GEOSHIELD Verification Report

Galiford Try Building

Greenhead College

Gas membrane to specification BS8485 2015

VERIFICATION ITEM ONE

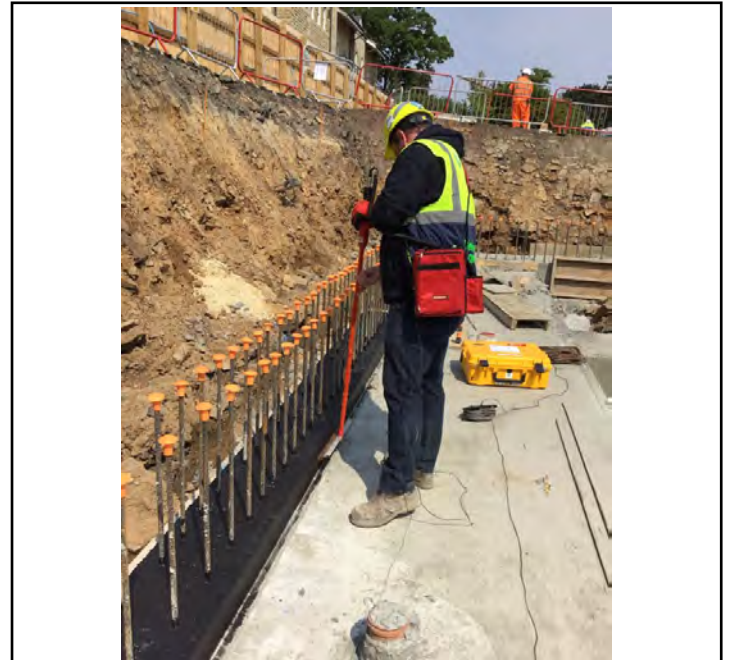
A visual inspection was first carried out to make sure a good coverage had been achieved and no water was on the wall. The dielectric test was then carried out on the retaining wall kicker. Some small pinholes were found during the testing, indicated by

the machine beeping, some were then picked up visually. Where they were not visible a larger area was then remediated.

VERIFICATION ITEM ONE

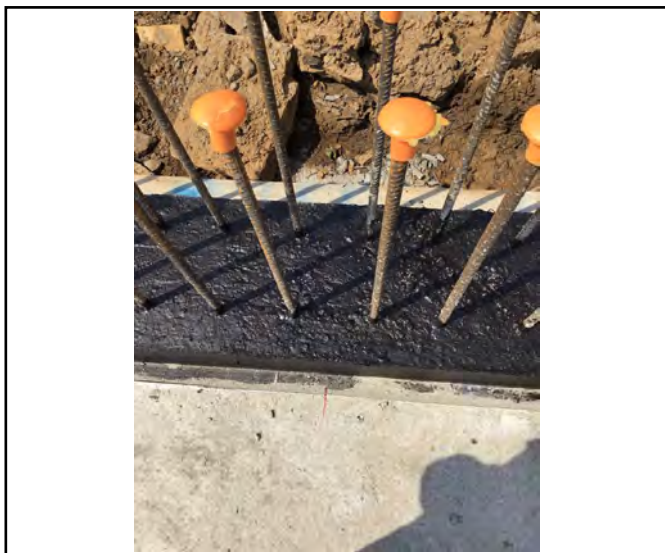
Above shows the remediation of a larger area. All areas indicated by the dielectric machine were remediated on site.

VERIFICATION ITEM TWO

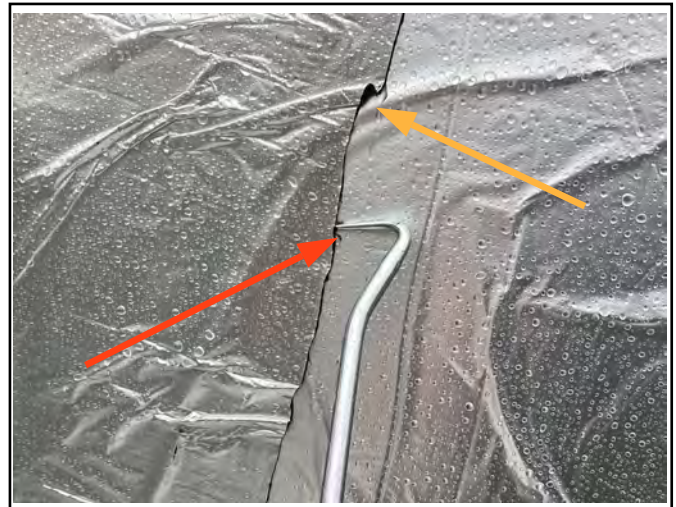
Photos showing the Mechanical Stress Point Test being undertaken as indicated with the red arrows. All available lap joints were checked ensuring there were fully sealed.

There were a couple of areas where there was creasing to the Visqueen Gas Resistant Self-Adhesive Membrane during application. The crease indicated with the yellow arrow was a potential capillary leak but upon further investigation, there was no risk of ground gas entering at this point. The crease was pressed flat during this visit.

VERIFICATION ITEM TWO

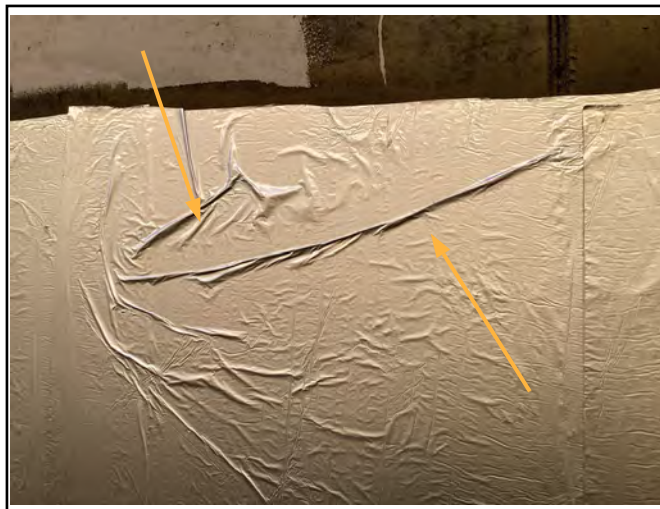
of ground gas entering at this point. The crease was pressed flat during this visit.

VERIFICATION ITEM THREE

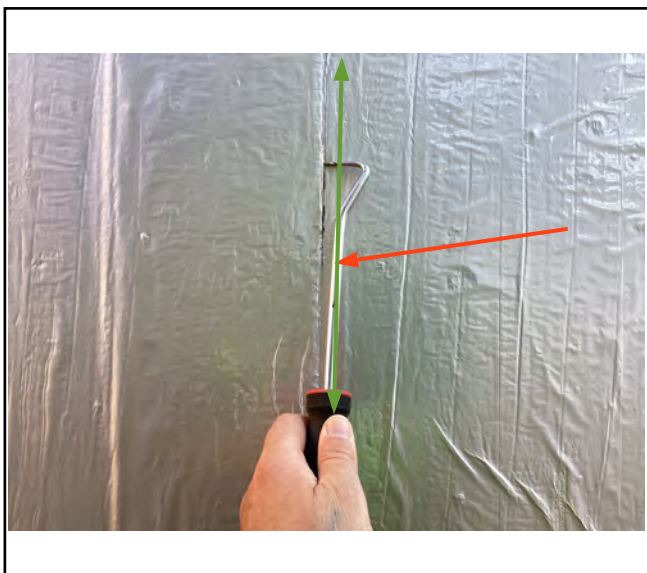
Overview of the Visqueen Gas Resistant Self-Adhesive Membrane where there are small creases within the Visqueen Gas Resistant Self Adhesive Membrane.

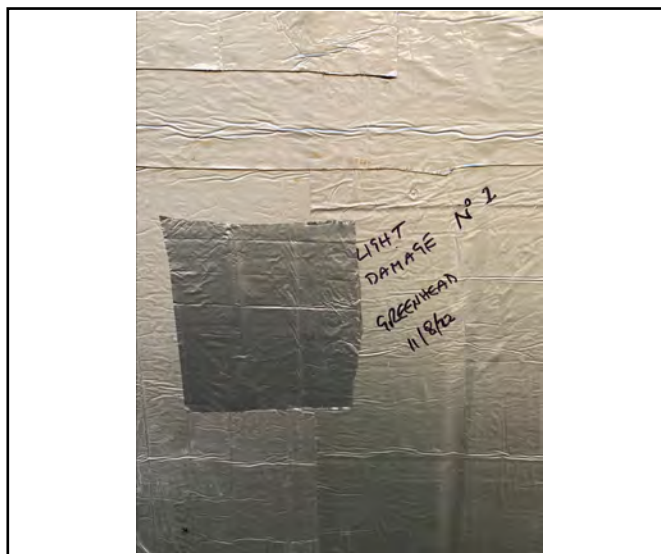
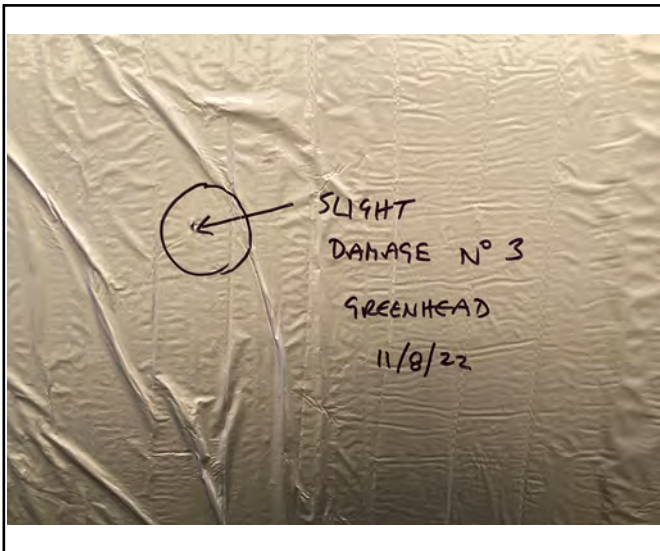
Small area of damage (1) to GRSAM
requiring remediation

GRSAM damage at (1) remediated
and fully sealed.

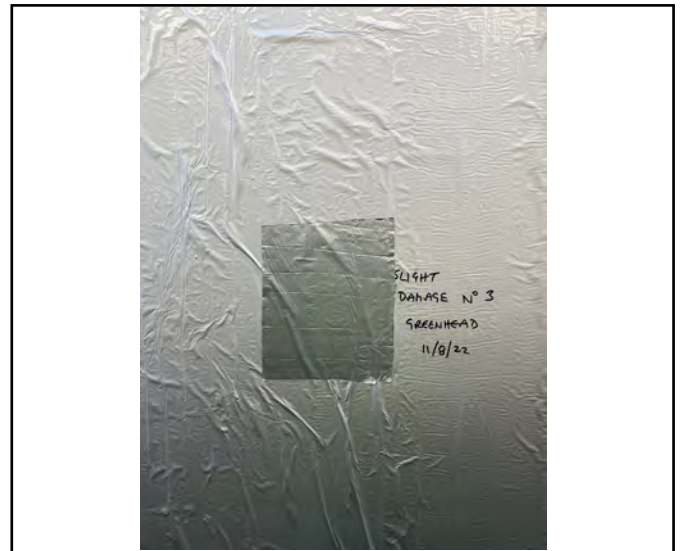
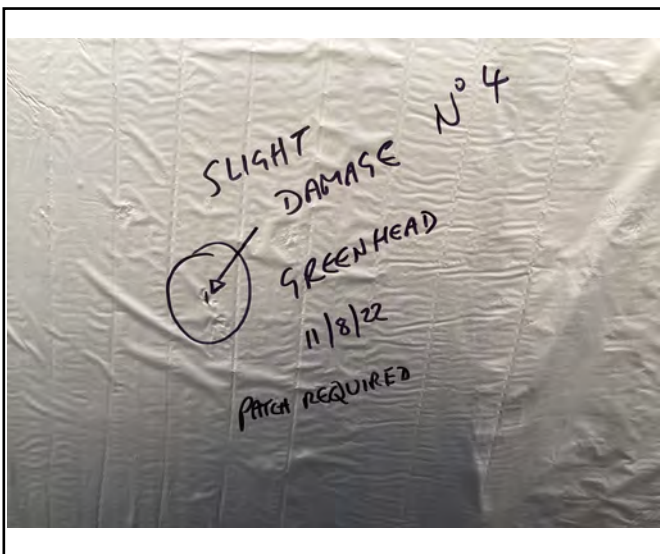
Small area of damage (3) to GRSAM

requiring remediation

GRSAM damage at (3) remediated

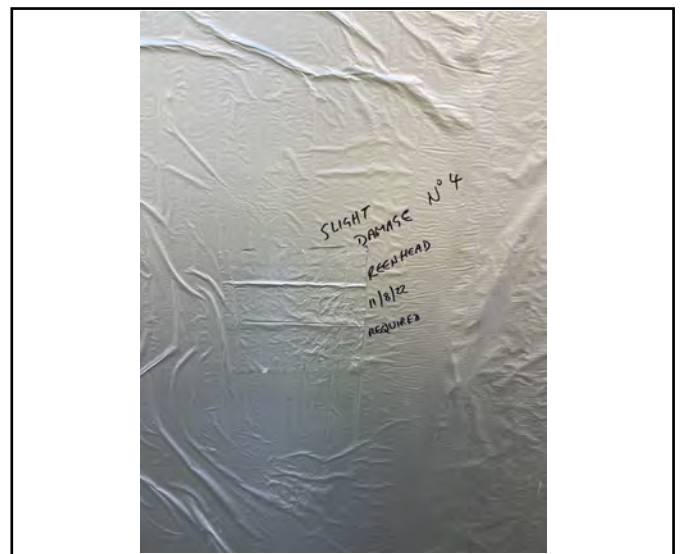
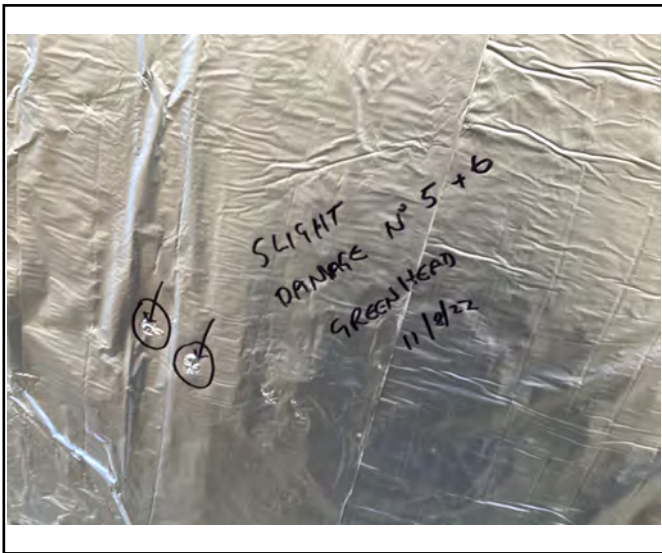
Small area of damage (4) to GRSAM

requiring remediation

GRSAM damage at (4) remediated

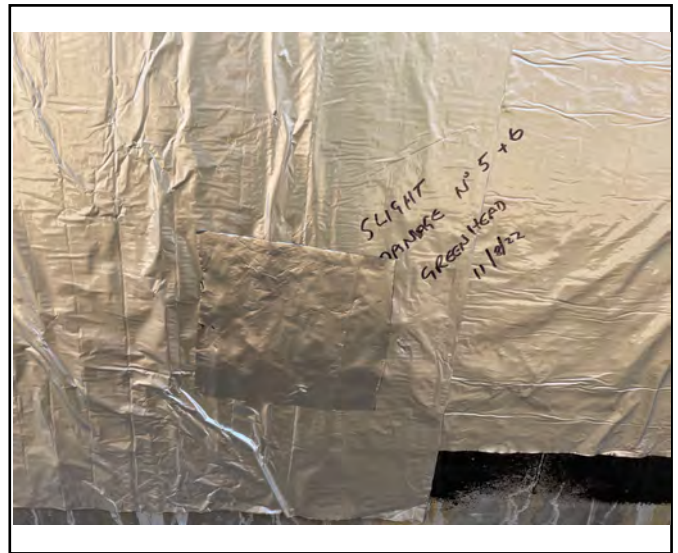
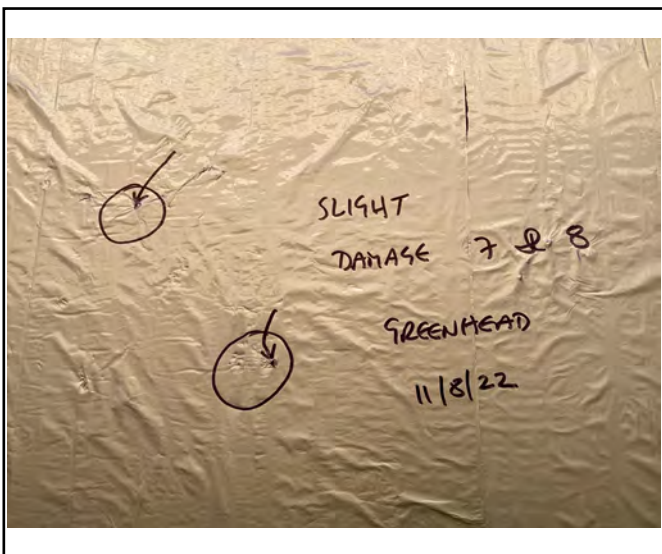
Small area of damage (5 & 6) to

GRSAM requiring remediation

GRSAM damage at (5 & 6)

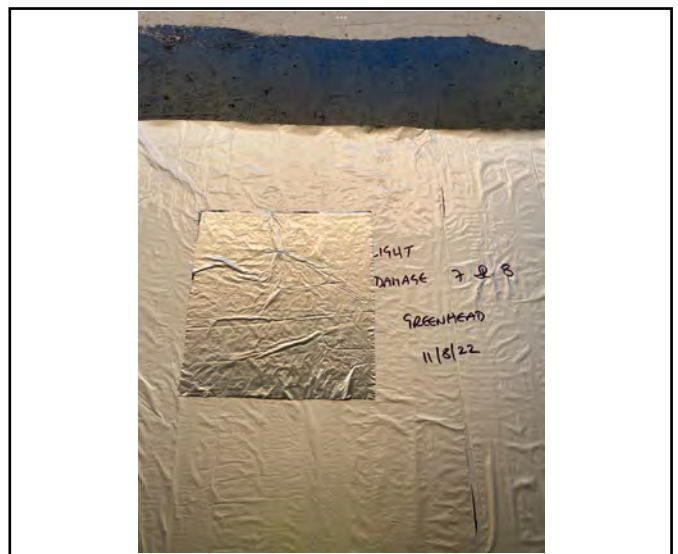
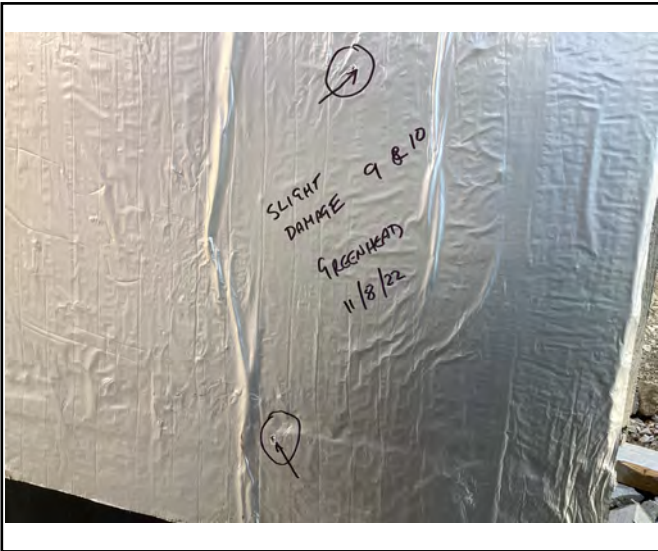
Small area of damage (7 & 8) to

GRSAM requiring remediation

GRSAM damage at (7 & 8)

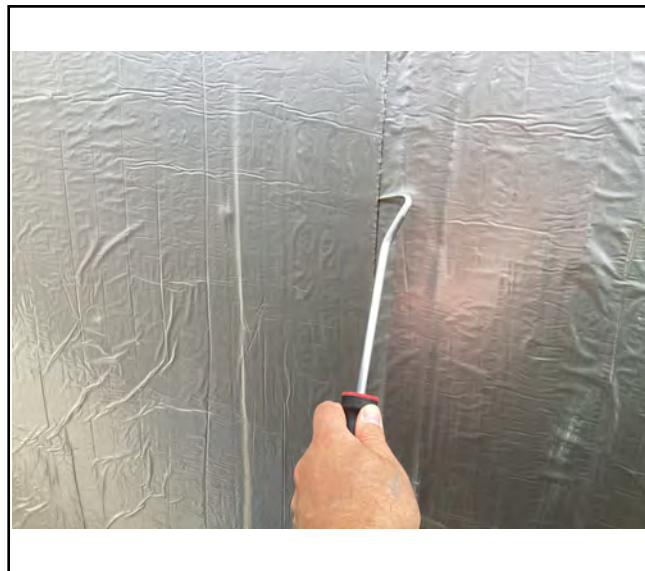
The Visqueen Gas Resistant Self Adhesive Membrane had been installed along the retaining wall which had been previously primed using bitumen primer identified with a red arrow on photo 1.

Photo 2 showing the Mechanical Point Stress Test being undertaken along the edge of the vertical lap joints. The purpose being to ensure there were capillary leak risk and no issues were identified during the verification.
